Project	IEEE 802.16 Broadband Wireless Access Working Group < http://ieee802.org/16 >
Title	Frame Partitioning for H-FDD Operation
Date Submitted	2008-03-10
Source(s)	E-mail: Pallav Sudarshan Pallav.Sudarshan@motorola.com Jeff Zhuang Jeff.Zhuang@motorola.com Mark Cudak Mark.Cudak@motorola.com Motorola, Inc. < http://standards.ieee.org/faqs/affiliationFAQ.html >
Re:	IEEE 802.16 Working Group Letter Ballot Recirc #26b
Abstract	Clarifications and signaling mechanisms are provided for efficient operation of H-FDD in 802.16e.
Purpose	Accept the proposed specification changes on IEEE P802.16Rev2/D3.
Notice	<i>This document does not represent the agreed views of the IEEE 802.16 Working Group or any of its subgroups. It represents only the views of the participants listed in the "Source(s)" field above. It is offered as a basis for discussion. It is not binding on the contributor(s), who reserve(s) the right to add, amend or withdraw material contained herein.</i>

Frame Partitioning for H-FDD Operation

Figure 59—Example of burst FDD bandwidth allocation

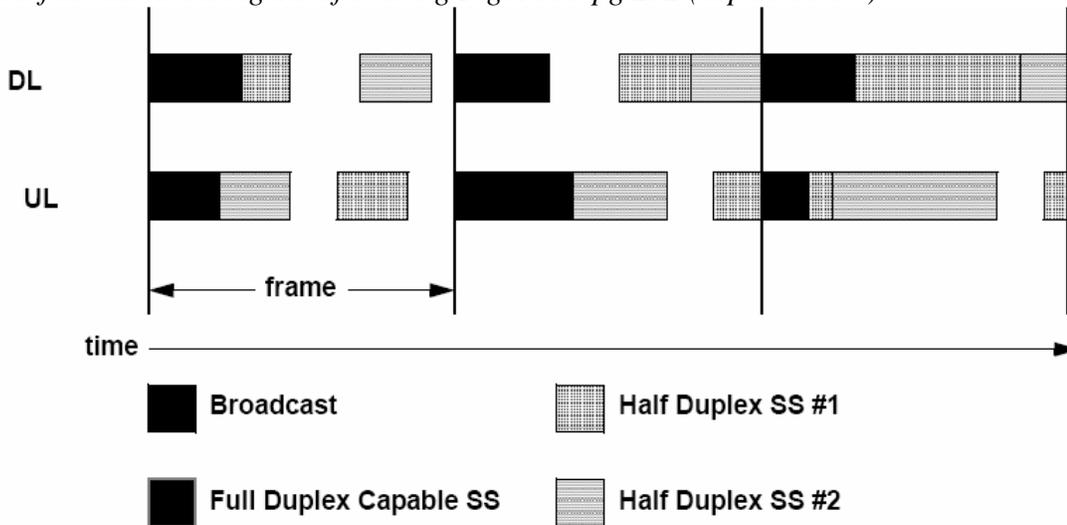
Modification to the legend of existing Figure 59 pg 292 (copied below):

Fig 59 should denote the different temporal regions more generically as “**Half Duplex Partition #1**” and “**Half Duplex Partition #2**”, instead of “Half Duplex SS #1” and “Half Duplex SS #2”.
